Re: Lookout Lot 5 (PTS 482904)

LOOKOUT - LOT 5

SITE PLAN
LUSAB Meeting
SCALE: 1/8" = 1'-0"

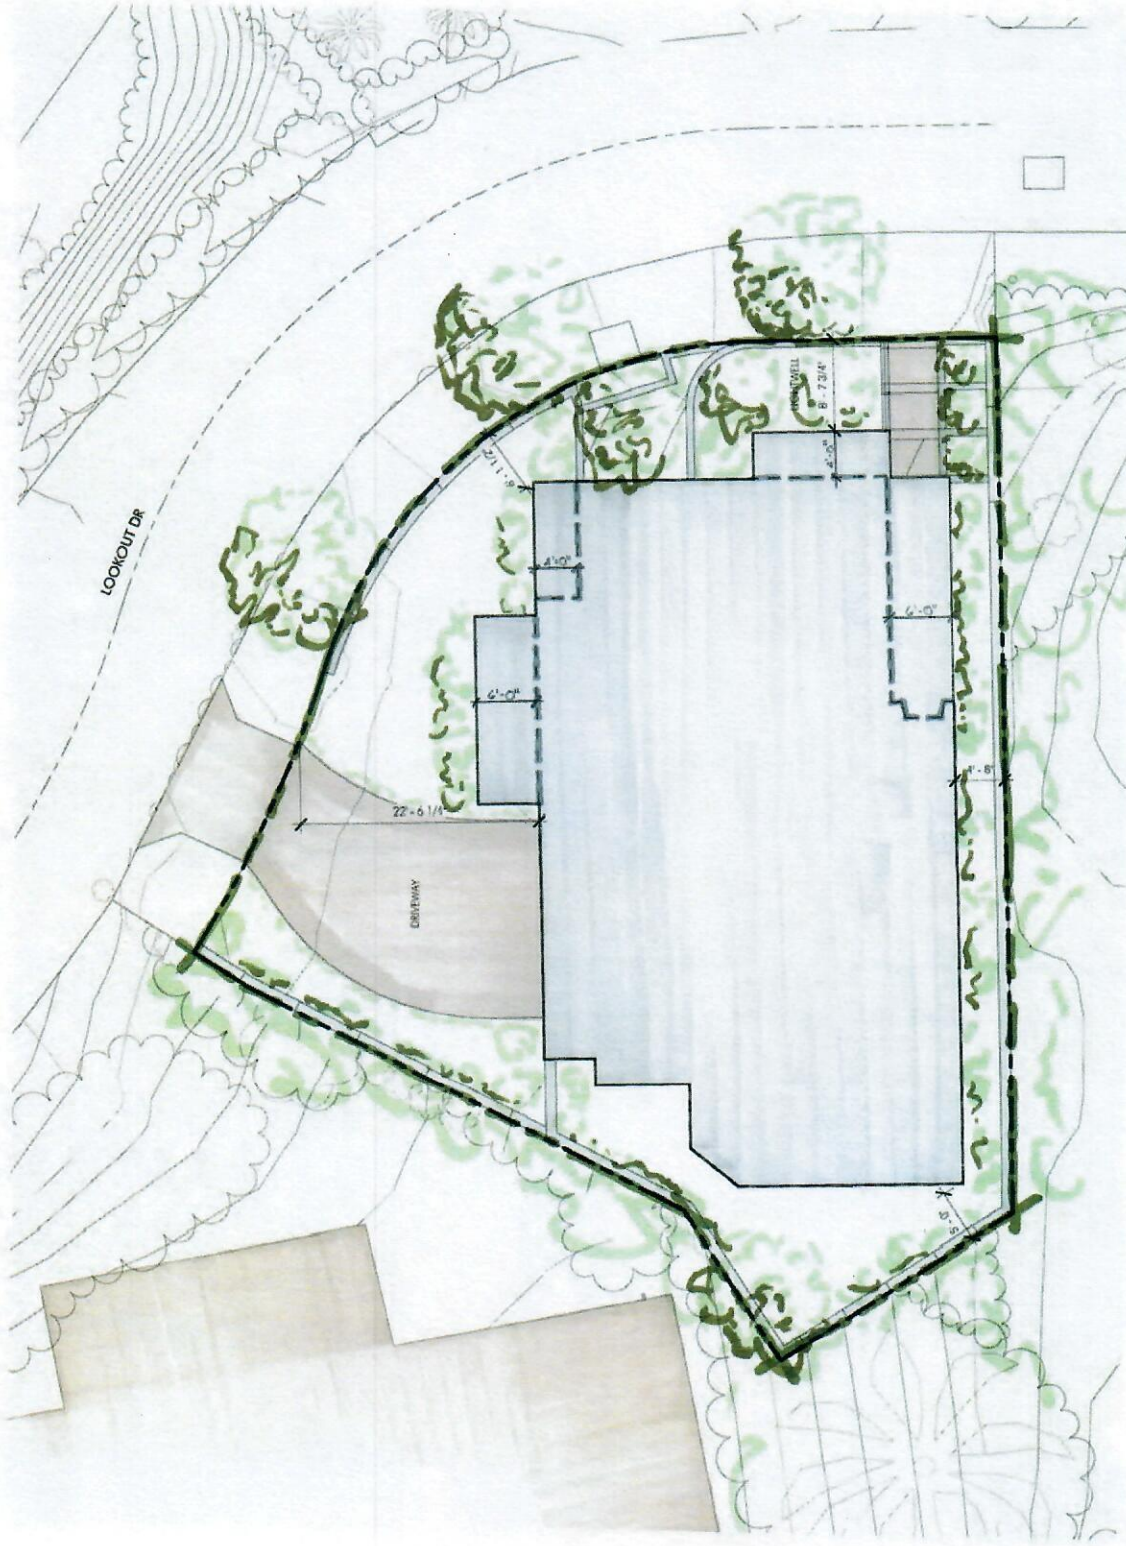
Here, the proposed structures on Lookout Lot 5 would be separated by a claimed distance of four feet, eight inches, barely exceeding the required minimum setback of four feet, from the rear property line of Lookout Lot 5, which abuts Ms. McKean's southern property line. It is apparent from reviewing the applicant's neighborhood survey that Ms. McKean's single-family residence was constructed in close proximity to its southern property line. (See Exhibit A (Ms. McKean's property is identified as Number 32 (with Lookout Lot 5 identified as Lot 38).) In fact, it is the master bedroom of Ms. McKean's home that is located closest to the southern property line abutting Lot 5.

The four-foot, eight-inch separation of the structure proposed on Lookout Lot 5 from Ms. McKean's side property line abutting her bedroom is much lower than the average setback from the side property line in the neighborhood survey prepared by the applicant. The applicant's latest neighborhood survey shows that the average side yard setbacks are six feet, seven inches to six feet, ten inches. It should be noted, however, that the applicant's calculated side yard setbacks improperly included the minimal setbacks of proposed development for Lookout Lots 2 and 5, and excluded the much larger side yard setback of the developed lot at 7716 Lookout Drive. See Exh. A. If the side yard setbacks for proposed Lookout Lots 2 and 5 were excluded from the applicant's calculation, as they should have been, and the side yard setbacks for the developed lot at 7716 Lookout Drive were included, as they should have been, the average side yard setbacks in the neighborhood survey would be considerably higher than six feet, seven inches, to six feet, ten inches. Even with the applicant's errors in calculating average side yard setbacks within 300 feet, which errors result in an understatement of actual average side yard setbacks in the neighborhood, the applicant's calculated average side yard setback is far above the four-foot, eight-inch setback from Ms. McKean's yard by almost two feet (23 inches), or **41 percent**. Accordingly, the proposed development of Lot 5 is not in general conformity with the building setbacks in the vicinity and thus violates SDMC section 1501.0304(b)(4).
